**WHEELING PLAN COMMISSION
THURSDAY, FEBRUARY 22, 2018 6:30 P.M.**

REQUEST FOR PLAN COMMISSION ACTION
STAFF PROJECT REVIEW

RE: Docket Nos. 2017-18 and SCBA 18-4
Shri Swaminarayan Temple
397 Northgate Parkway
(2017-18) Special Use-Site Plan Amendment to Allow for a
Building Addition
(SCBA 18-4) Appearance Approval of a Freestanding Sign

LANDSCAPE PLAN

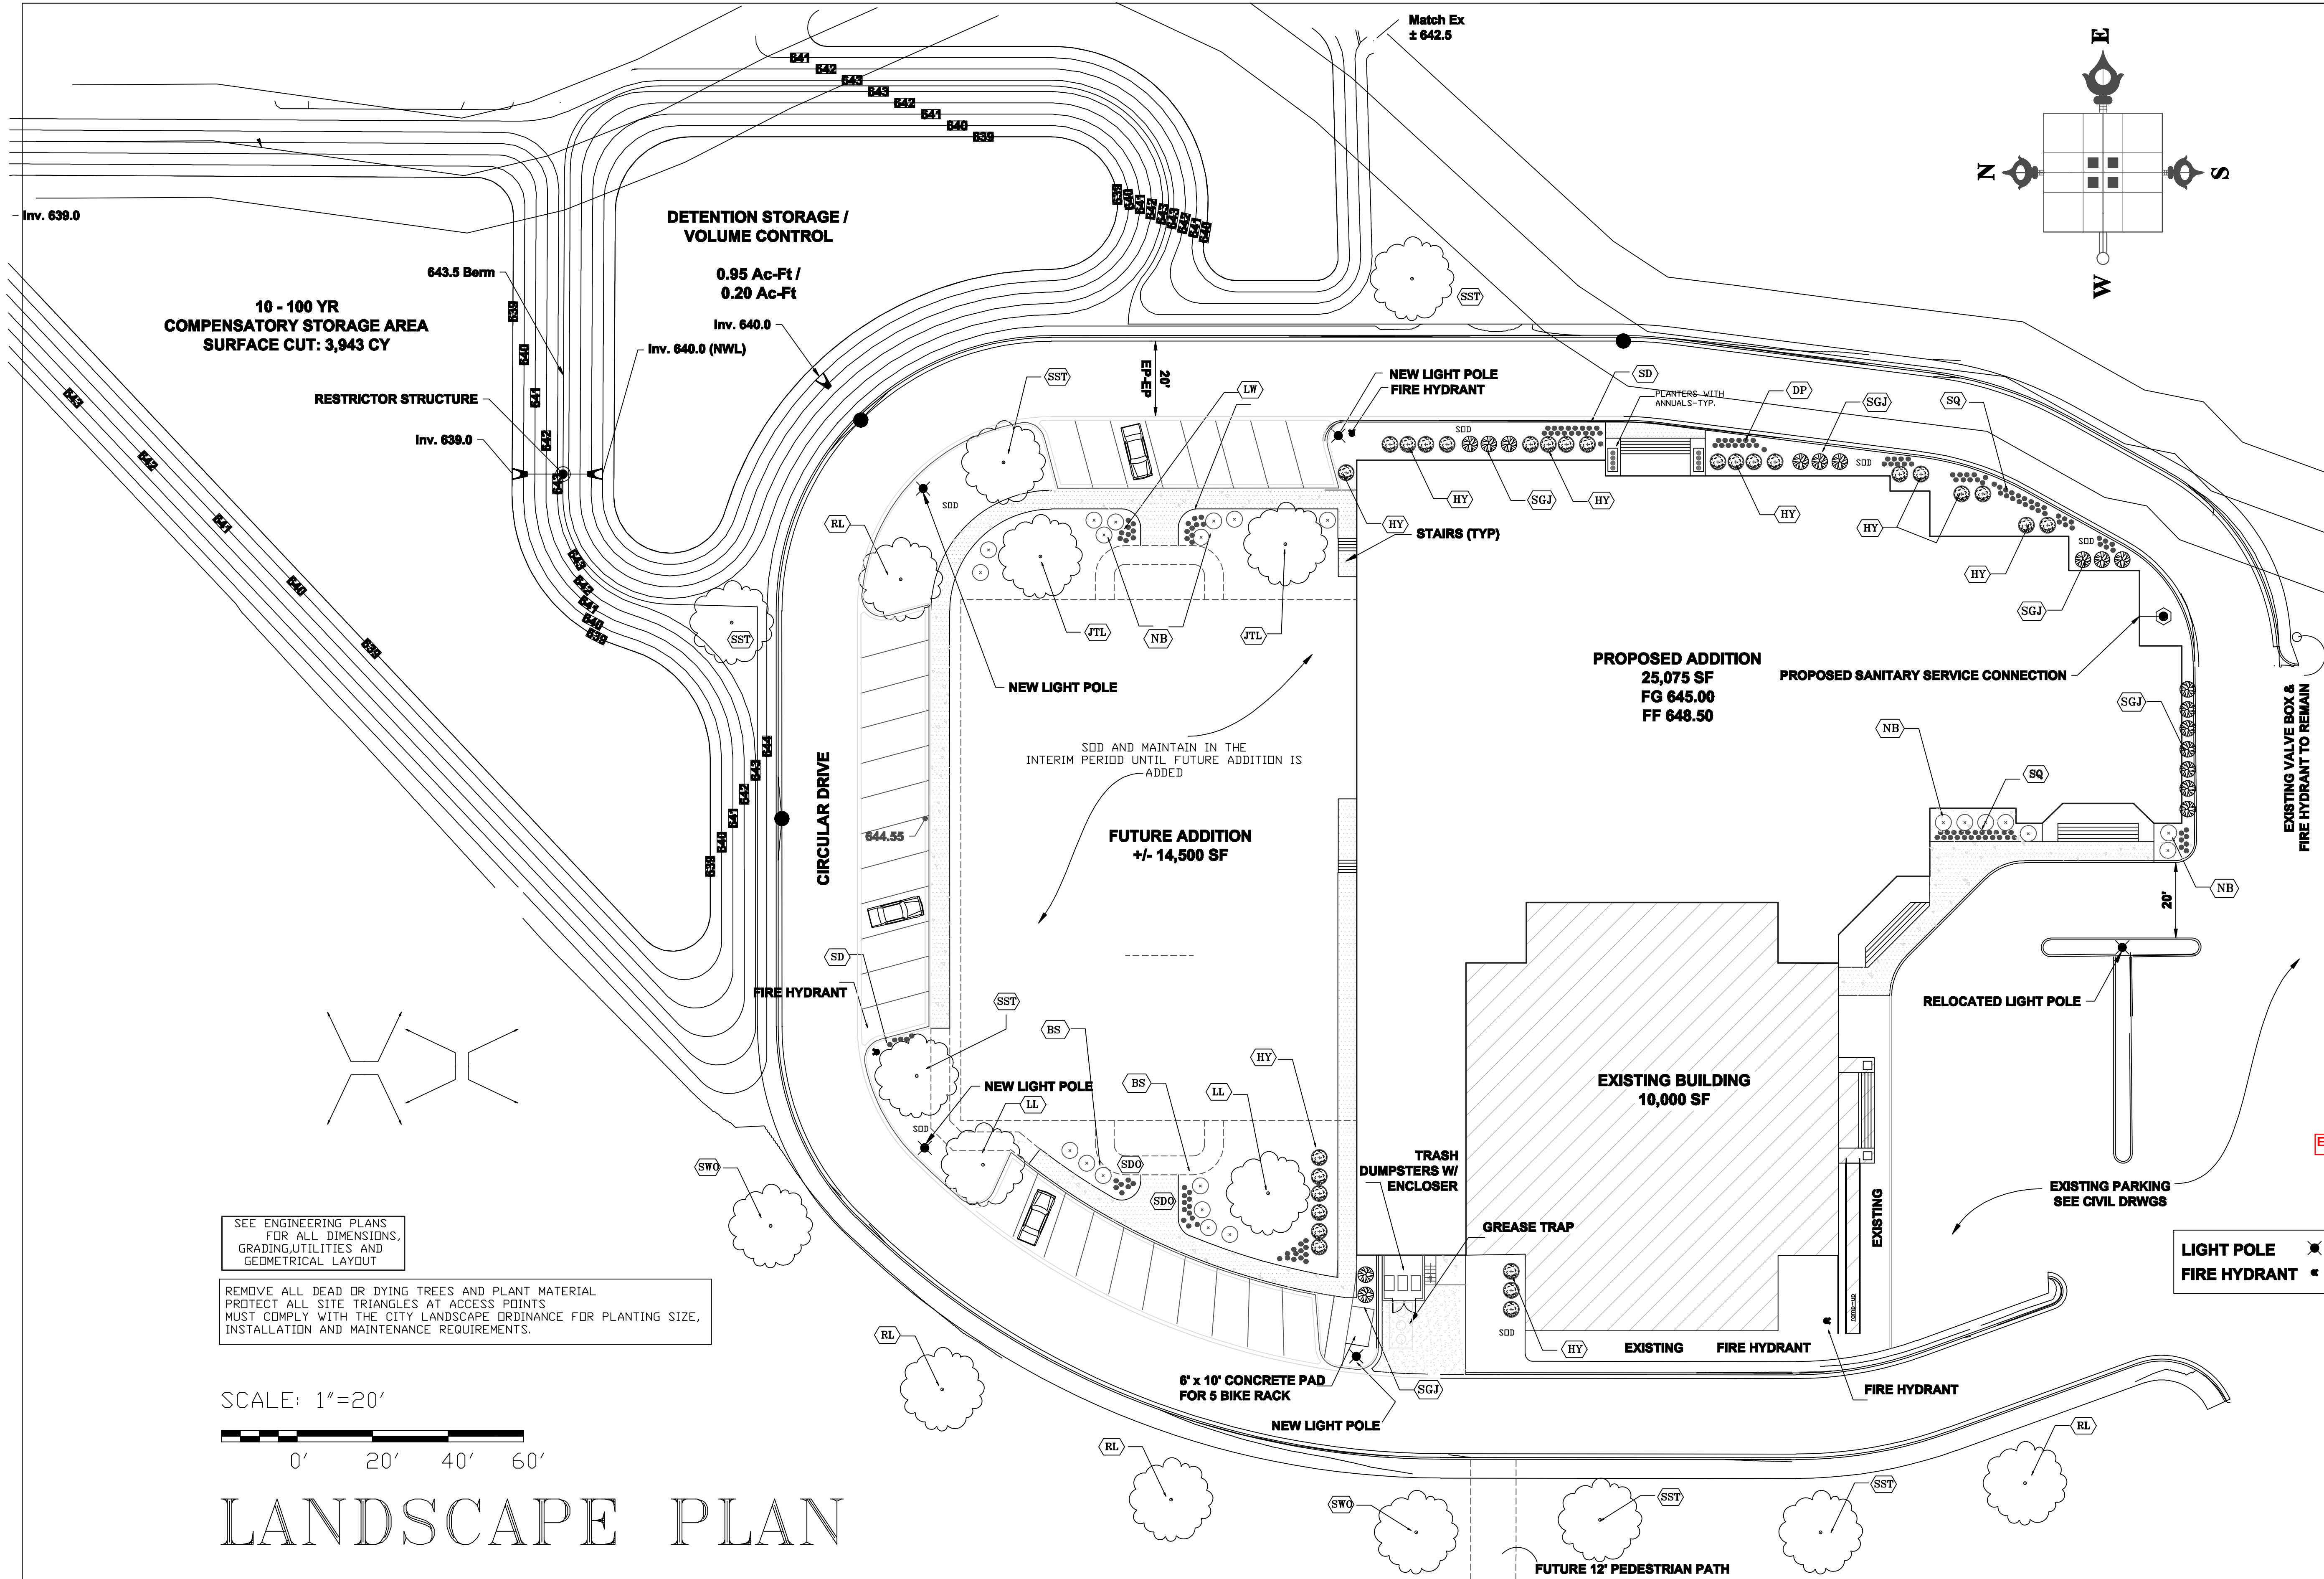
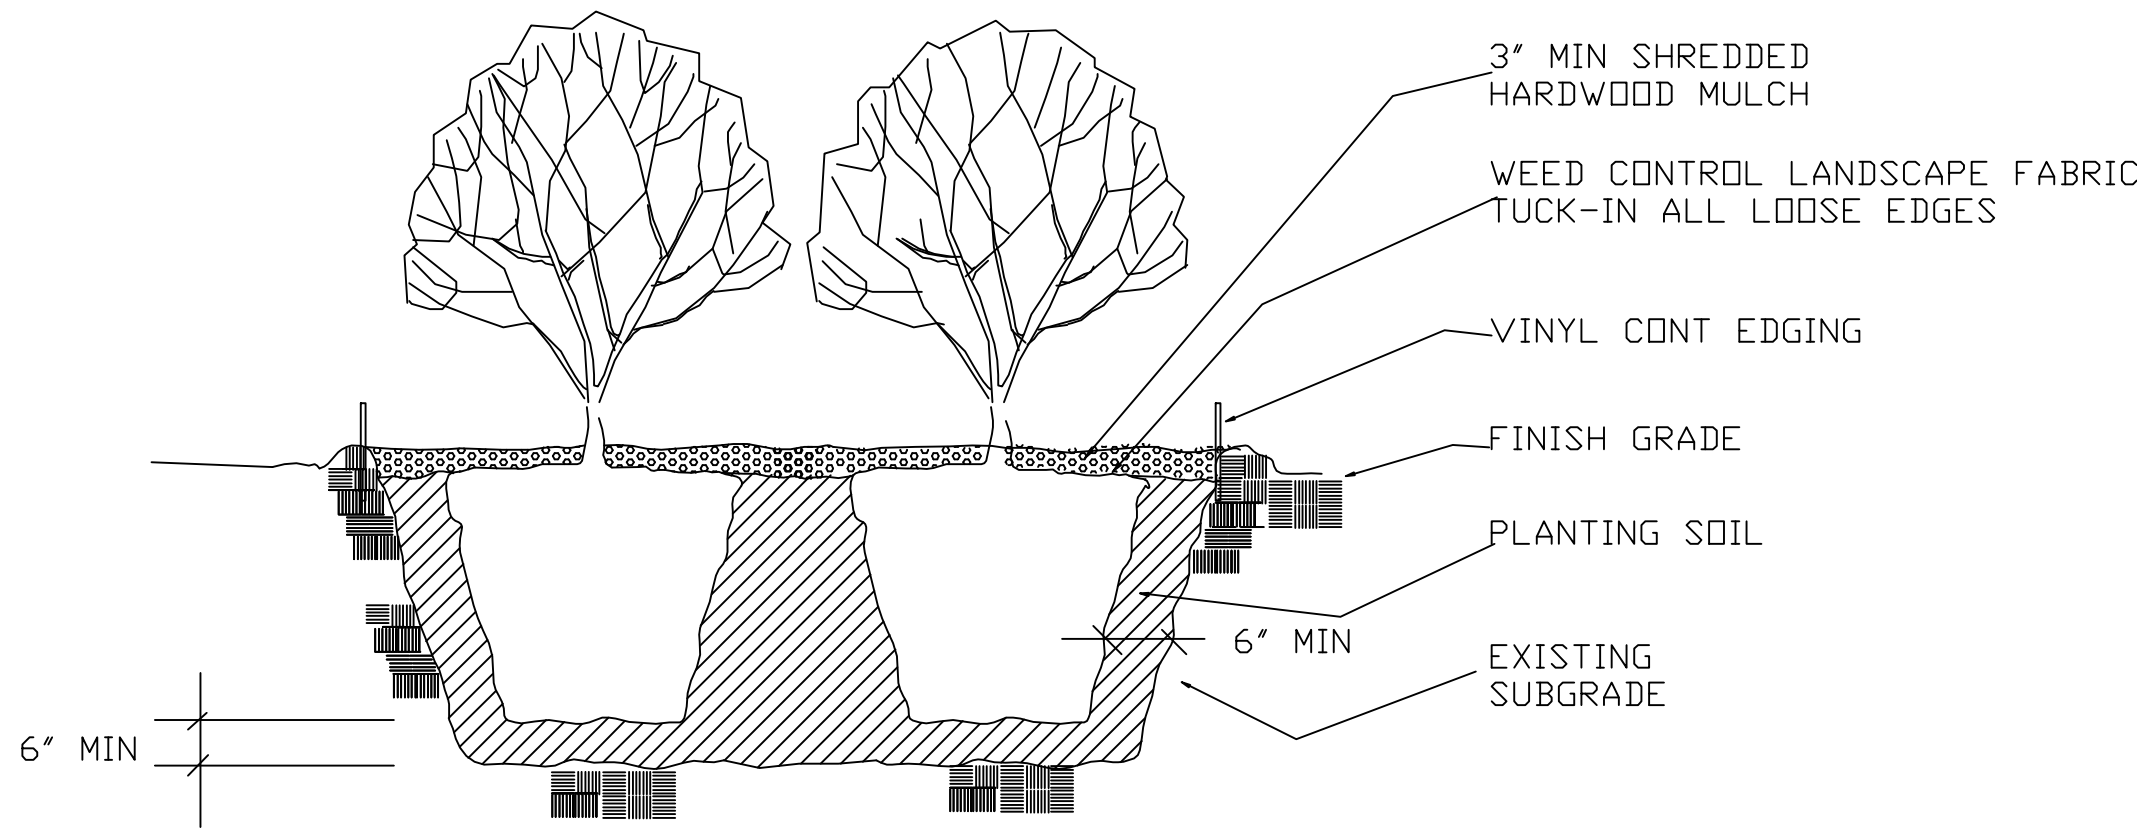
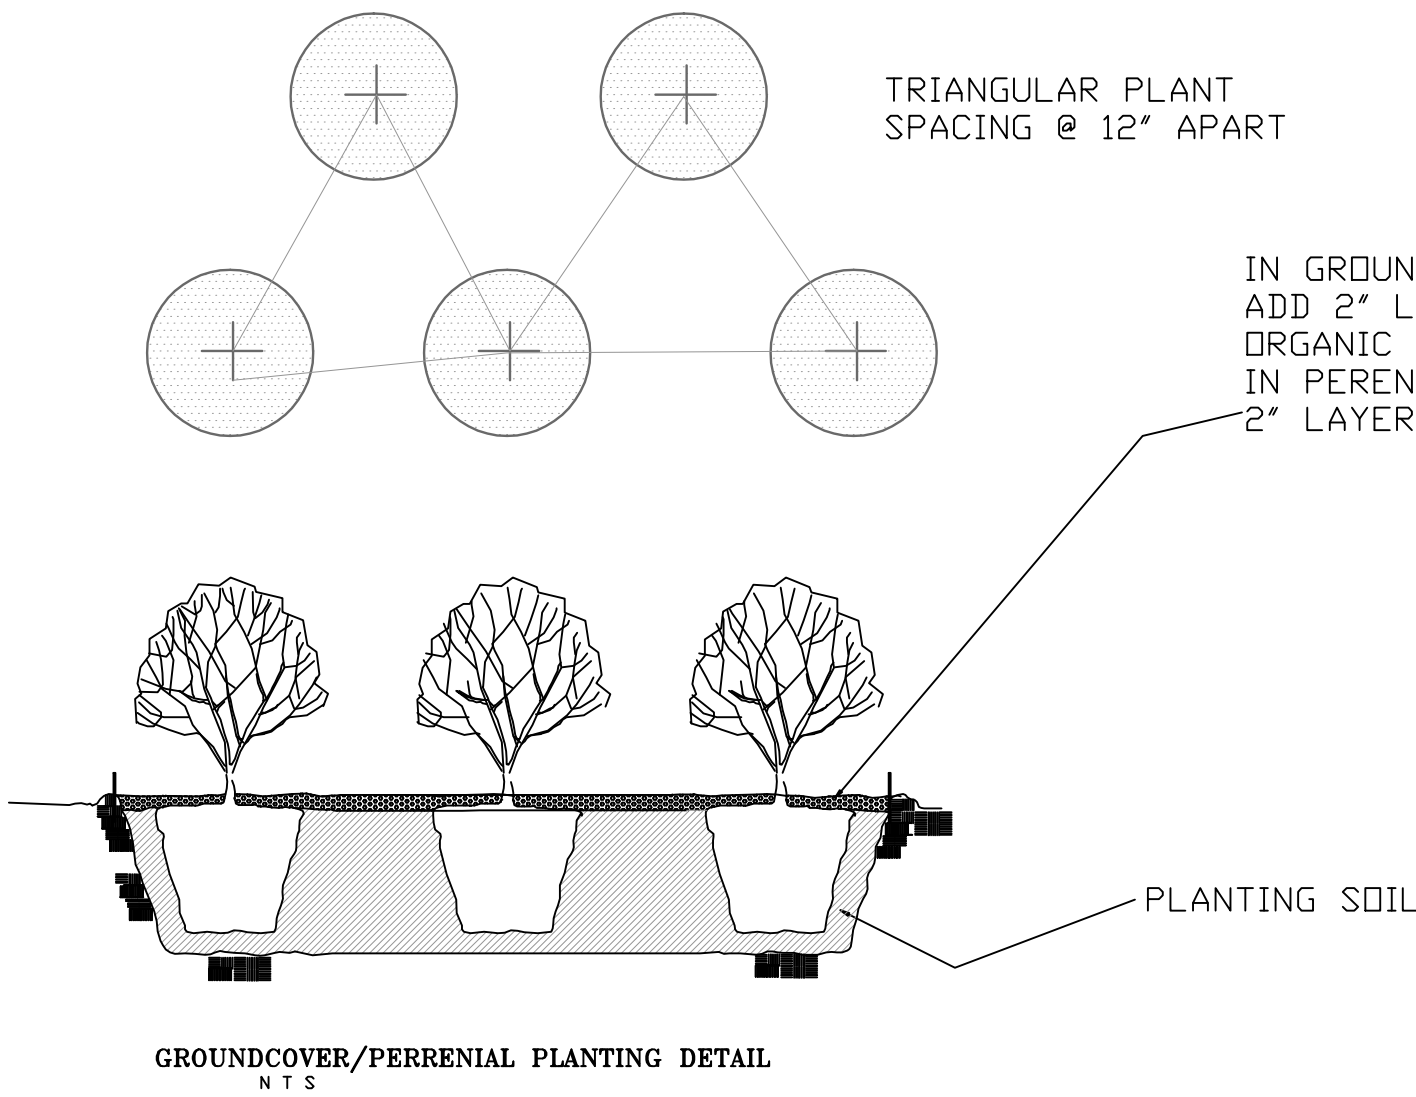
6. Bike parking locations and quantities shall be noted on the plan. **The landscape plan notes the location of a pad for five bike racks.**
7. The photometric plan shall be updated to reflect the wall mounted lighting and to increase lighting and dim areas. **A revised plan has been provided.**

Bicycle Parking: Bicycle parking for five is provided on the landscape plan.

SOUTH ELEVATION

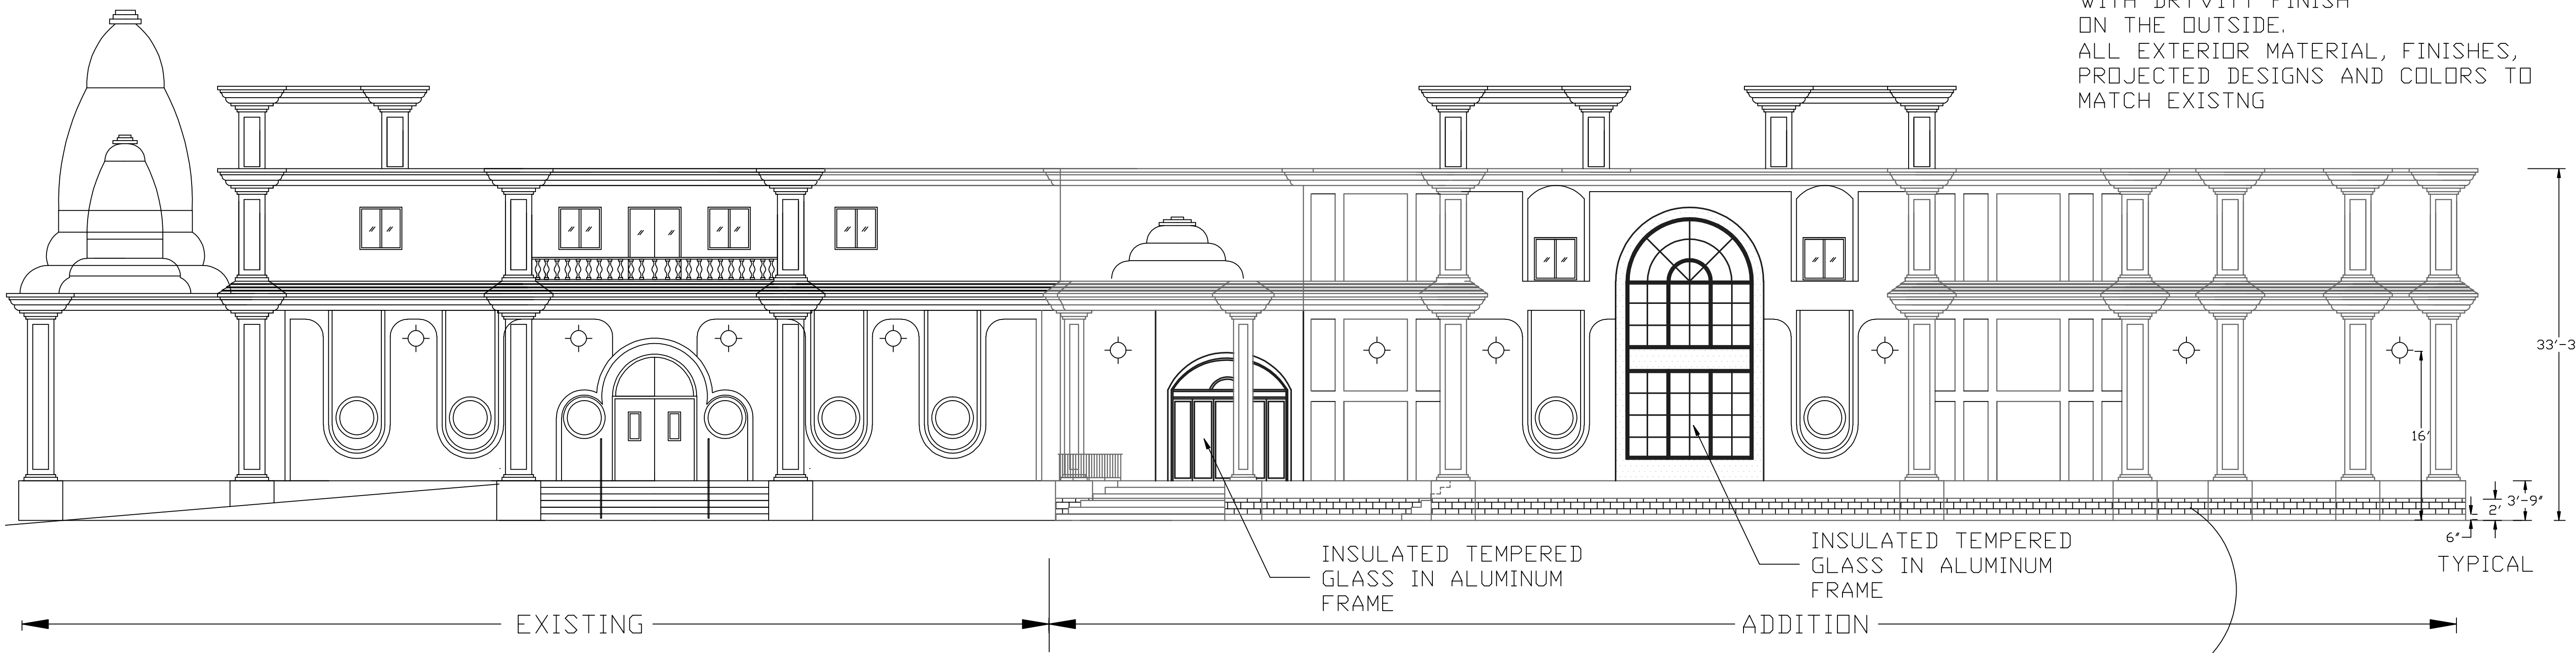
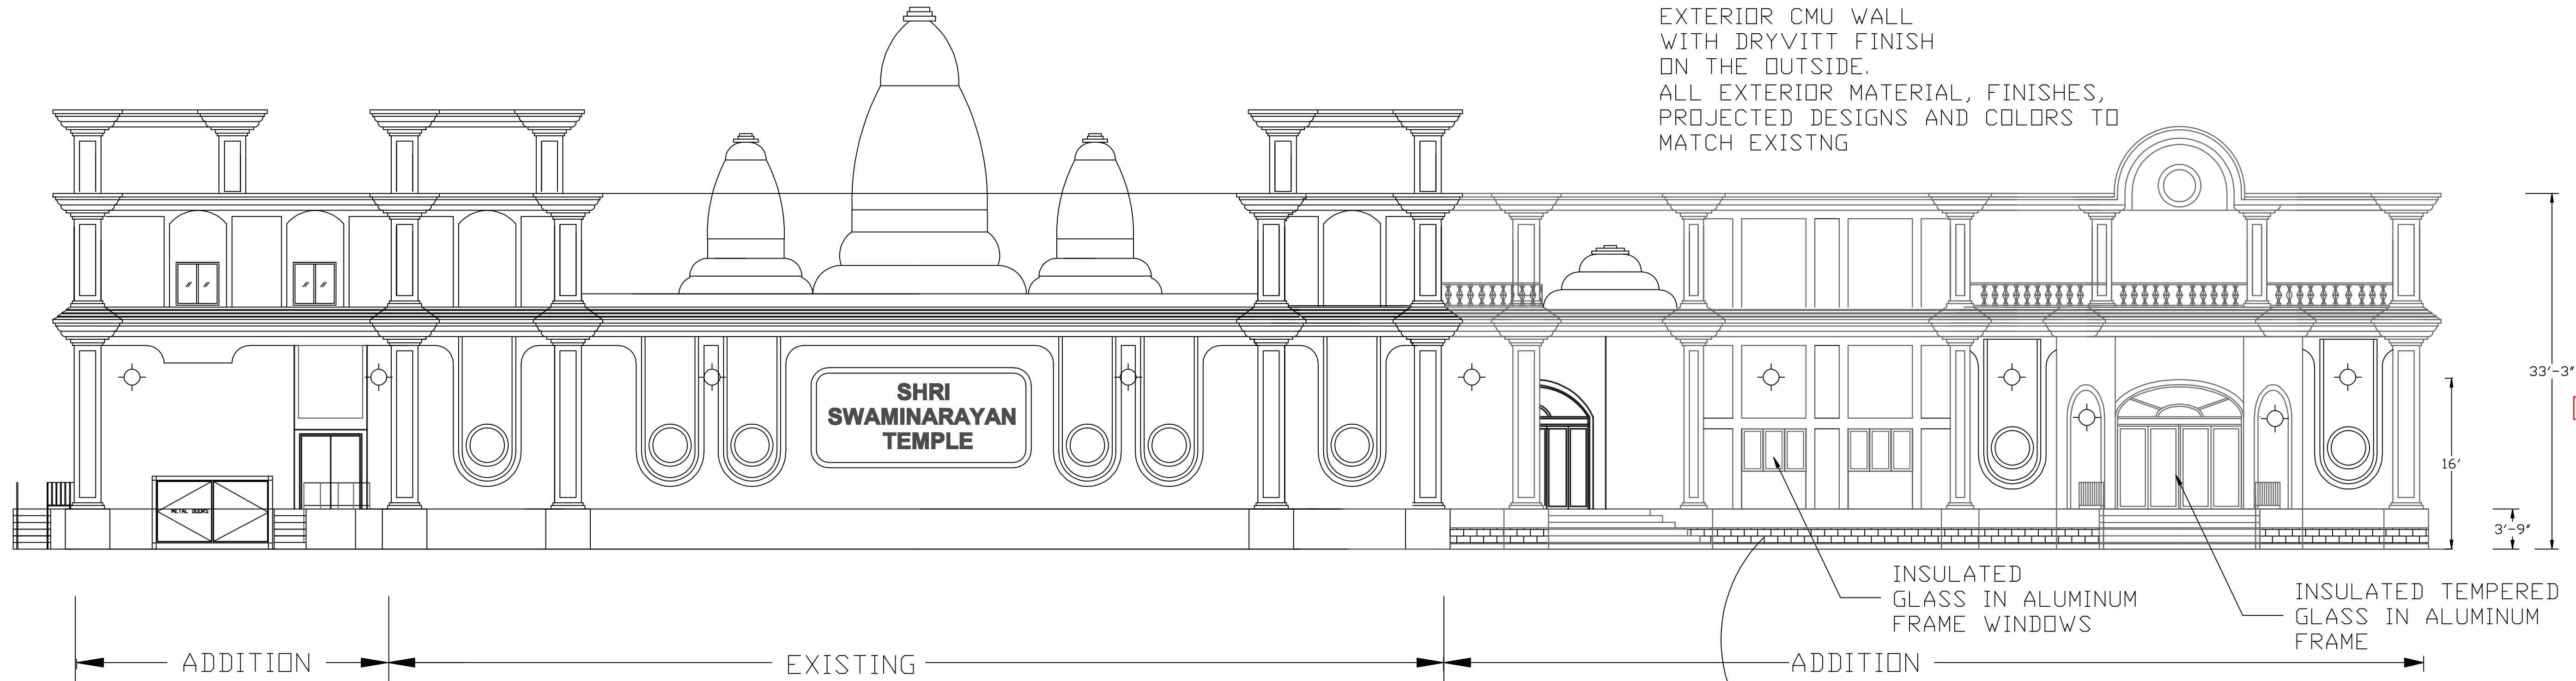
4. A minimum of 12" of the exterior walls from finished grade shall be made of a more durable material than EIFS. **The elevation plans note a 16" cast concrete masonry "Prairie Stone" at the building addition's base.**

The elevation plans for the 25,075 sq. ft. addition state that it will match the design, material, finishes, and colors of the existing temple. This includes continuation of the Dryvitt (EIFS) primary wall material. The design guidelines recommend that EIFS not be used as a primary wall material. However, the Plan Commission may allow the continued use on the addition for design continuity. At the Plan Commission's request, a more durable material is shown at the base of the building addition. A 16-inch cast concrete masonry "Prairie Stone" is proposed for the base material.
